**STAFF REPORT**  
(One-Step Final Plat)

**CASE NUMBER:** SUB 2000-47 -- MID CONTINENT AIRPORT 4th ADDITION

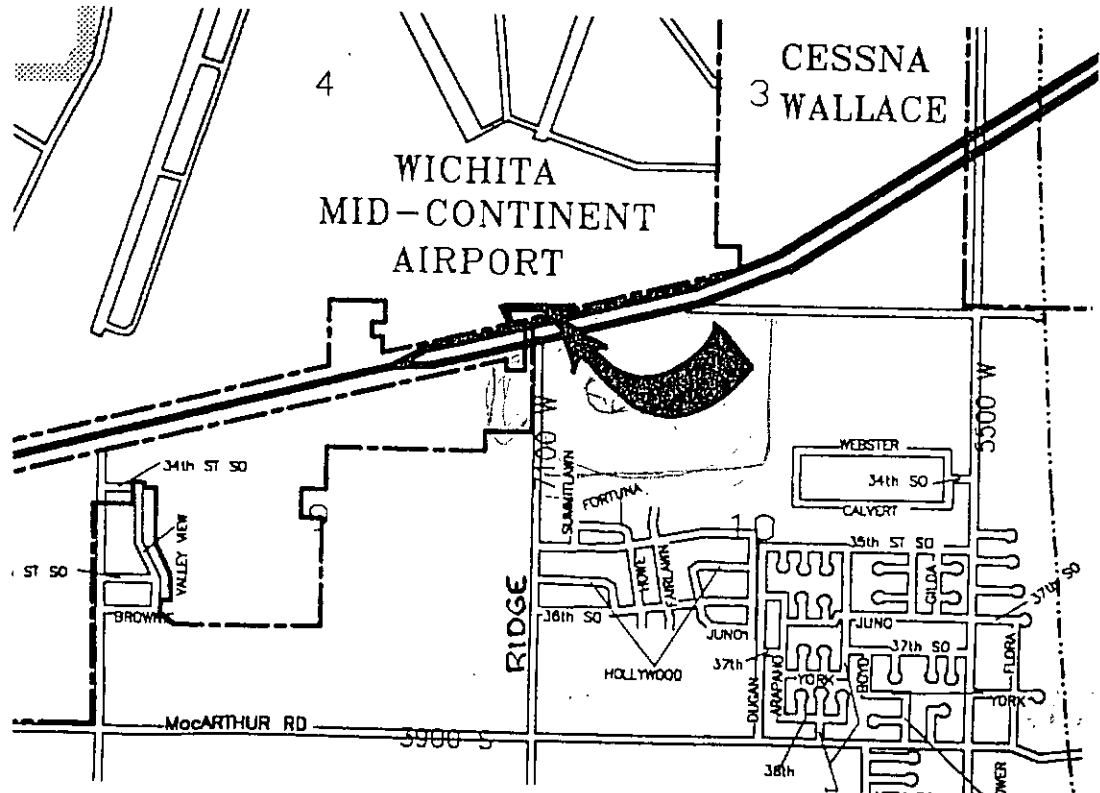
- A. Sanitary sewer appears to be available to serve the site. The Applicant shall guarantee the extension of City water to serve the lot. City Engineering needs to comment on the need for any guarantees or easements.

- C. City Engineering needs to comment on the status of the applicant's drainage plan.
- D. KDOT needs to comment on the access controls. The plat indicates one opening along K-42 Highway.

- E. The applicant shall submit an avigational easement covering all of the subject plat and a restrictive covenant assuring that adequate construction methods will be used to minimize the effects of noise pollution in the habitable structures constructed on subject property.
